Studebaker

SERVICE BULLETIN

NO. 274

1953

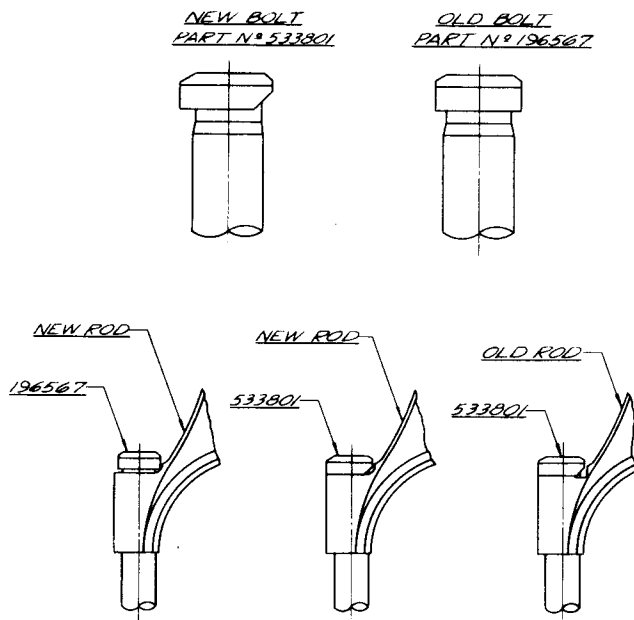
The machining of the inner edge of the connecting rod head seat in the upper half of the rod used in Champion-type engines is now changed to a form similar to that used in the Commander V-8 engines. The undercut along the inner edge of the seat is being abandoned in favor of a generous radius at this point. See the drawings. The use of this radius requires a corresponding change in the connecting rod cap bolt head to prevent interference.

But the new-type rod *must* use the new-type connecting rod cap bolt, Part No. 533801. This bolt can also be used with the original-type connecting rod. On the other hand, do not use the original-type connecting rod cap bolt (Part No. 196567) on the new-type connecting rod. Such use will cause interference between the bolt head and the rod radius, leading to rapid fatigue and possible breakage of the rod.

FIG. 1 - EXTENSION CASE ASSEMBLY, PART NO. 529984 FOR 1951, 1952, AND 1953 COMMANDER MODELS WITH STUDEBAKER AUTOMATIC DRIVE.

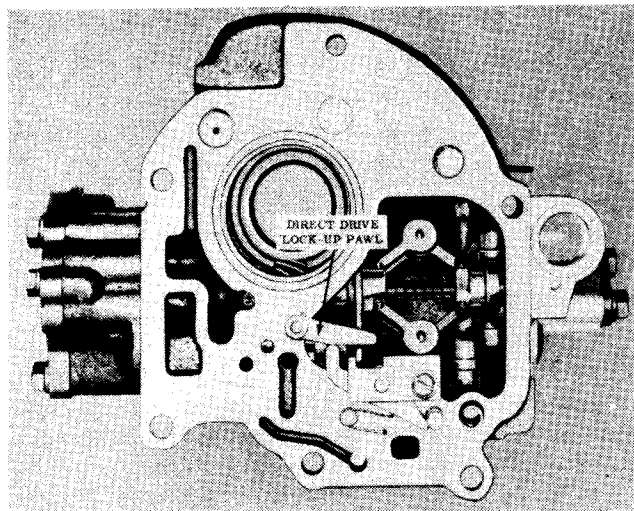
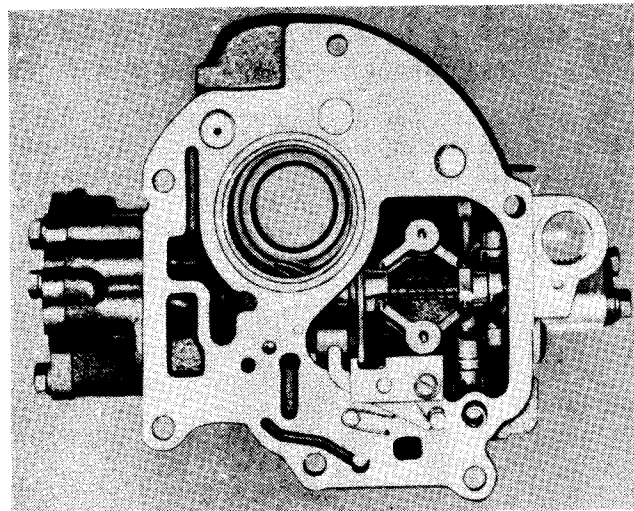
Only one extension case assembly, Part No. 529984 (see Fig. 1), will be furnished by parts depots for replacement purposes in 1951, 1952, and 1953 Commander models equipped with Studebaker Automatic Drive. The assembly is installed in 1953 Commander models after first removing the direct drive pawl (see Fig. 2).

If the owner *does not want* the part-throttle downshift, install the Part No. 529984 Extension Case Assembly exactly as you received it from your parts depot (see Fig. 1). This assembly has the direct drive lockup pawl in place and, to prevent part-throttle downshift, it should be retained.

If the owner wants the part-throttle downshift (operation like 1953 Commander and all Champion models with Automatic Drive), it is necessary only to remove the direct drive lockup pawl before you install the Part No. 529984 Extension Case Assembly. Thus modified, it will appear as shown in Fig. 2. The other related direct drive lockup parts need not be removed from the extension case assembly.
